UFSAR PAGE CHANGES

CHANGES TO
 UFSAR 7.6-11 d 11.4-1

TABLE 6.2-2 SUMMARY OF PRIMARY
CONTAINMENT PENETRATIONS AND
ASSOCIATED ISOLATION VALVES (Cont'd)

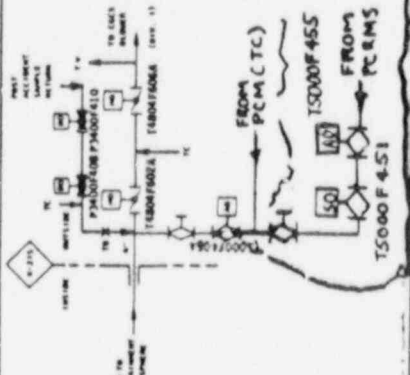
08721-2084 08721-2879-1	56	No	Drywell Pressure	TS000F420A (VS-2230)	BAL	AO	RM	M	-	-	-	-	0	0	0	0	0	A	Yes	Yes	Notes 2, 12, 13, and 15
	08721-2879-1	56	No	Containment Atmosphere Samples	TS000F401A (VS-2151) TS000F402A (VS-2152) TS000F403A (VS-2153) TS000F404A (VS-2154) TS000F405A (VS-2155)	BAL	AO	RM	M	-	-	-	-	0	0	0	0	0	B	Yes	Yes	See Penetration Detail X-27
					TS000F450 (VS-3063) TS000F456 (VS-2235)	GLB	SO	A	-	BK	BK	60	0	0	0	0	C	No	B	YES	YES	Add
					TS000F456 (VS-2235)	BAL	AO	A	M	BK	BK	60	0	0	0	0	C	No	B	YES	YES

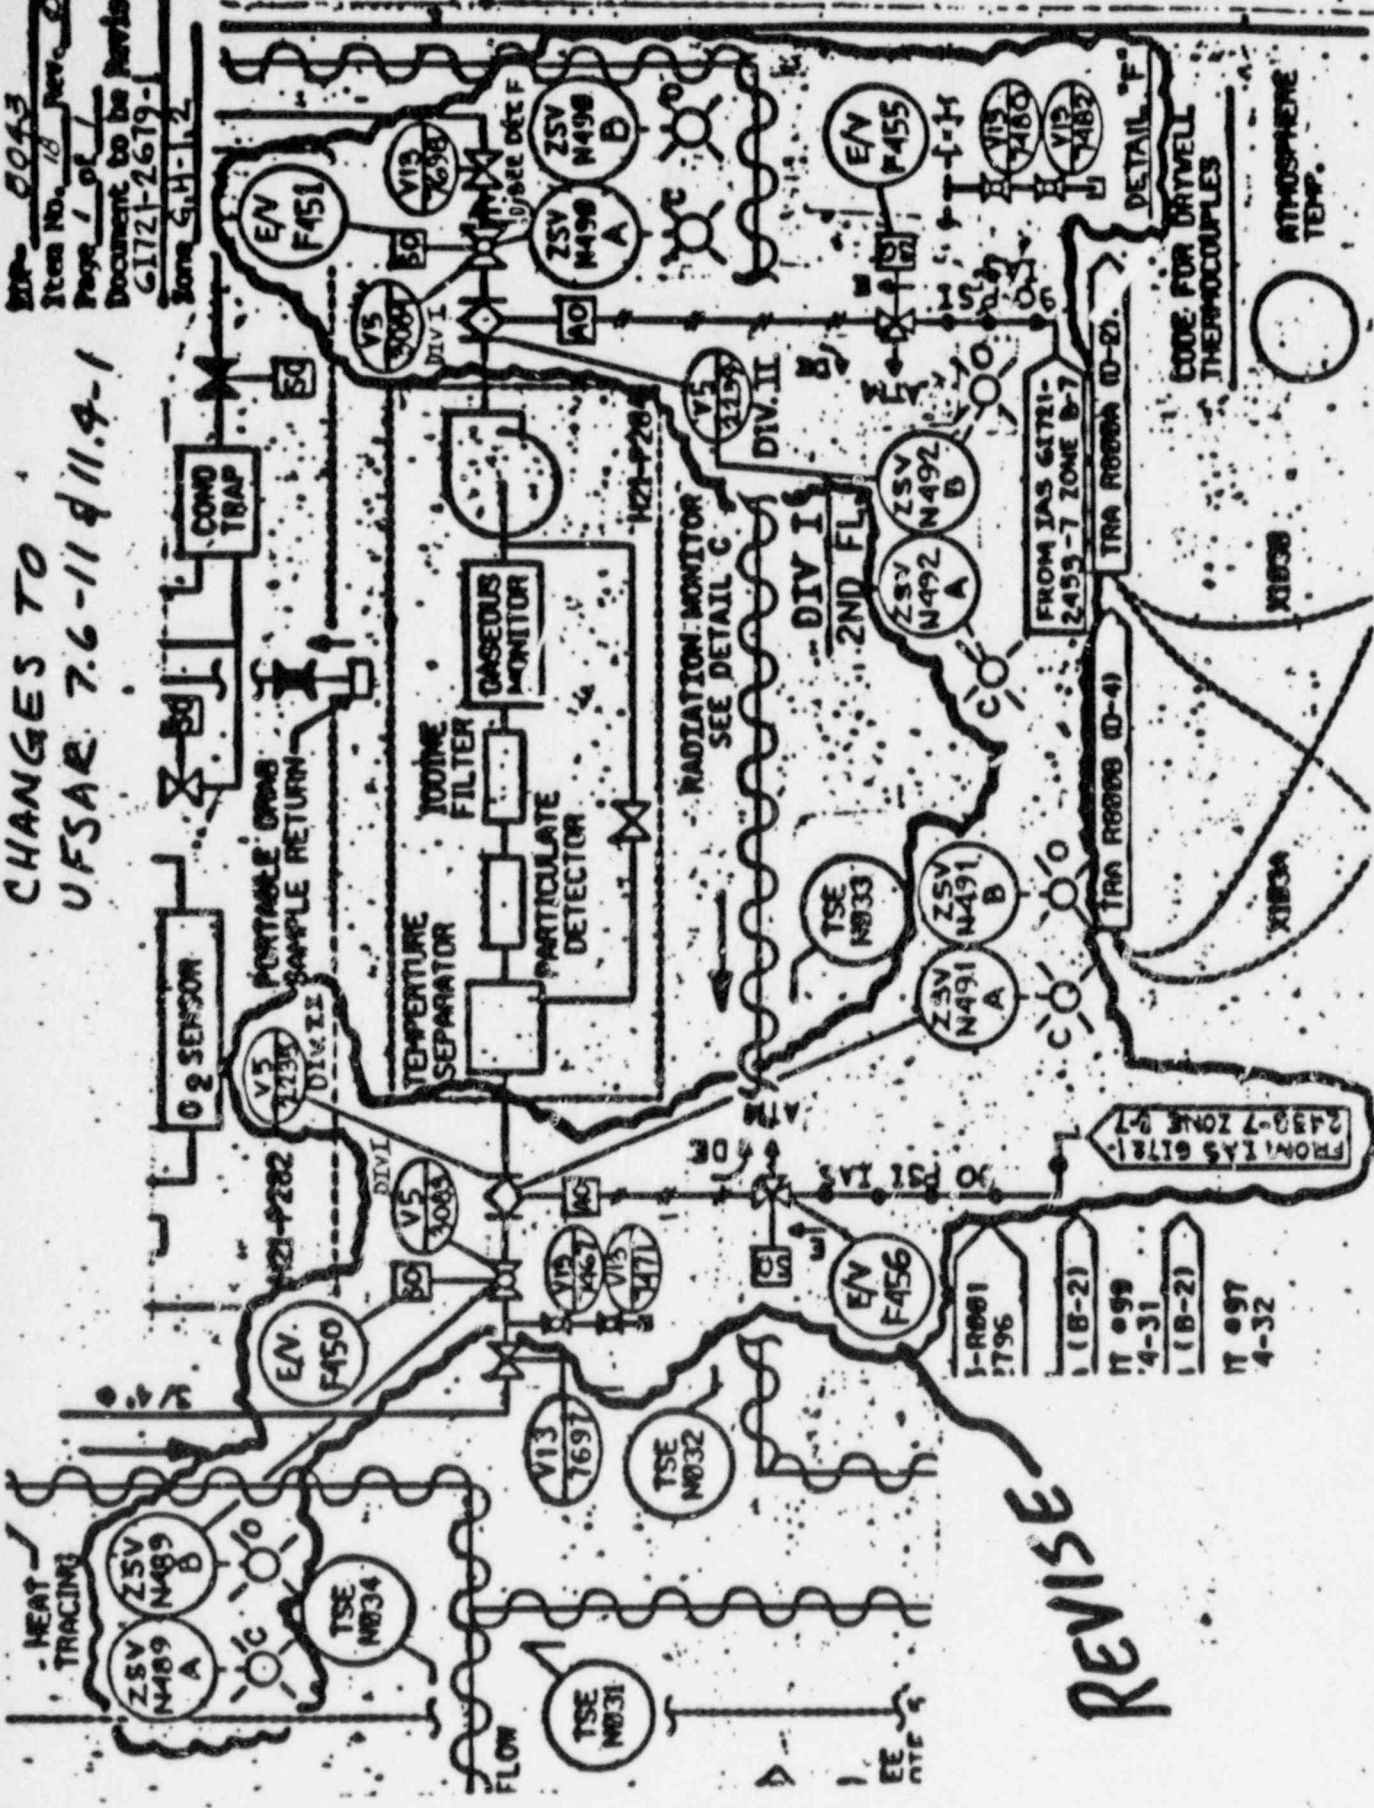
7.3.2.2.7.1	41	Added PCRMS to the listing of reactor level 2 isolation signals.
7.3.2.2.7.6	43	Corrected the high drywell pressure listing by adding torus water management.
		Added PCRMS to the list of high drywell pressure isolation signals.
Figures 7.6-11 & 11.4-1		Revisions to P&ID 6I721-2679-1 for the PCRMS isolation valves.

{ m. Torus water management.

{ n. Primary containment radiation monitoring.
